**Amendments to the Drawings:**

Attachment: Replacement Sheets for Figs. 1, 2, and 5  
Annotated Sheet Showing Changes

FIG. 1

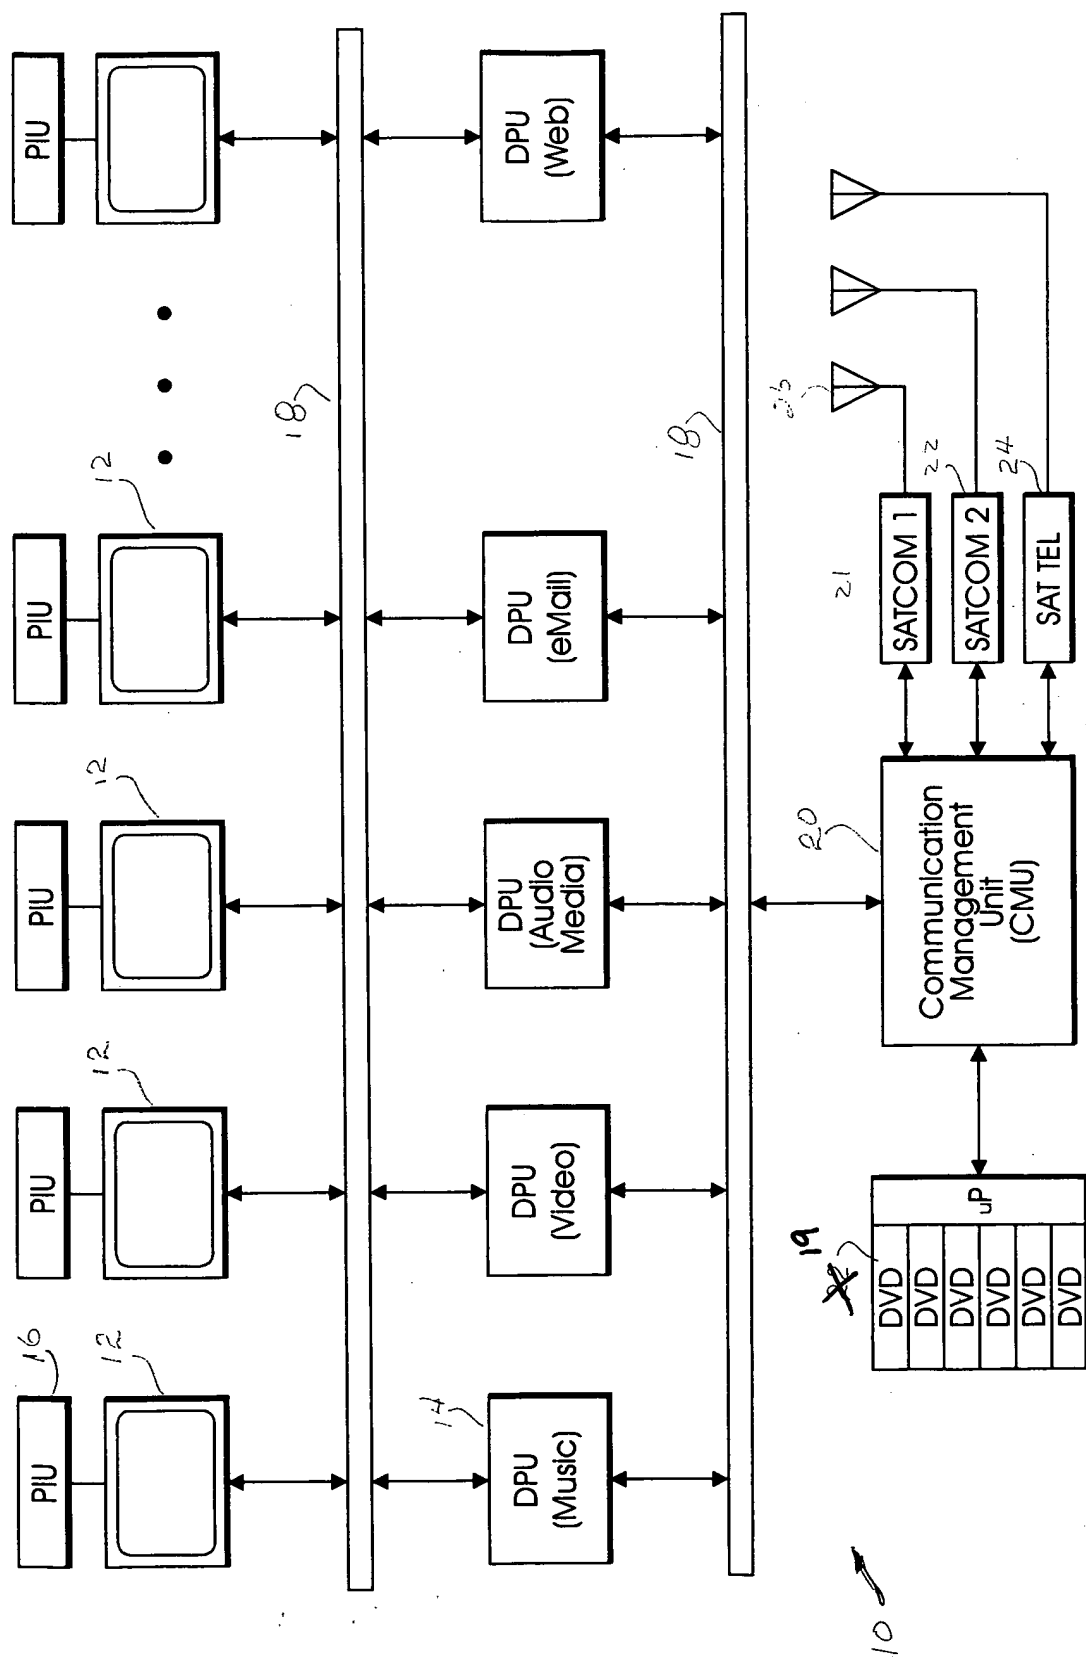
The attached sheets of drawings includes changes to Figs. 1, 2, and 5. These sheets, which includes Figs. 1, 2, and 5, replace the original sheets including Figs. 1, 2, and 5. In Figs. 1 and 2 the DVD 22 has been changed to DVD 19, and in Fig. 5 element 70 has been changed to element 71.

In the Office Action mailed July 18, 2003, the Examiner objected to the drawings of the present application. The drawings were objected to as failing to comply with 37CFR 1.84(p)(4) because reference character "18" had been used to designate both the upper and lower bus in Fig. 1. Also in Fig. 1, reference character "22" points to a DVD stack and SATCOM2. Further, in Fig. 5, reference character "70" points to the HDD and the NID. In addition, the Examiner objected to the drawings as failing to comply with 37 CFR 1.84(p)(5) for failing to mention the reference sign "64" in the description. The Examiner also objected to Fig. 1 because the top bus 18 separates the processors from the displays contrary to claim 1, and objected to Fig. 2 on the grounds that the displays (12) are shown and not the processors/memory (14) contrary to claim 1.

In response, the Applicant has amended Figs. 1, 2, and 5 and the specification of the present application. The Applicants respectfully submit that no new matter has been added. In addition, the Applicant respectfully submit that the specification of the present application states:

"[I]n the particular exemplary embodiment of FIG. 1, the signal bus 18 is depicted as lying between the multiplicity of DPUs and the multiplicity of display units, as well as between the multiplicity of DPUs and a communication management unit (CMU) 20. The particular configuration of the embodiment of FIG. 1 is solely for purposes of illustration and ease of explanation and is not intended to imply that there are two separate signal busses. Indeed, only a single network

bus is contemplated by the present invention, with the network bus interconnecting the multiplicity of electronics packages with, for example, an aircraft communication management unit 20."

FIG. 2

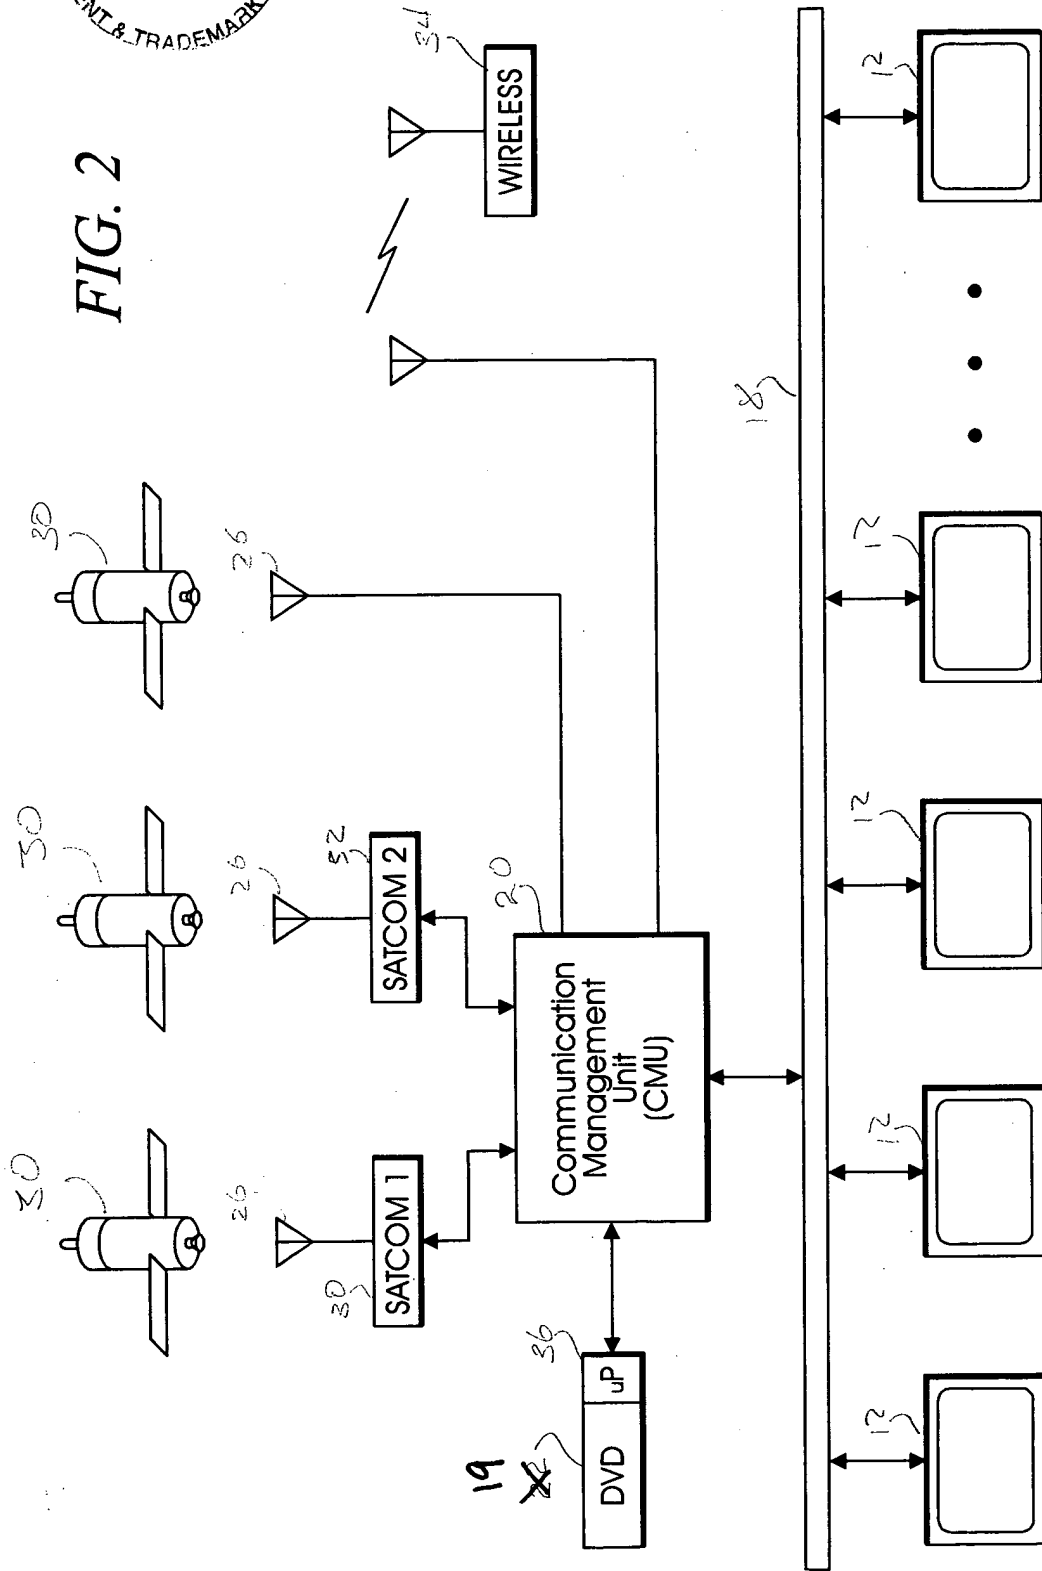
With respect to the Examiner's objection to Fig. 2 on the grounds that the displays (12) are shown and not the processors/memory (14) contrary to claim 1, the Applicant respectfully directs the Examiner's attention to the specification of the present invention which states:

"Although depicted in the exemplary embodiment of FIG. 1 as being separate from the display unit 12, the DPU 14 might well be integrated with the display in a complete electronic subassembly that, together with a suitable housing, can be inserted into a suitable receptacle provided any convenient location on the rear side of a passenger seat."
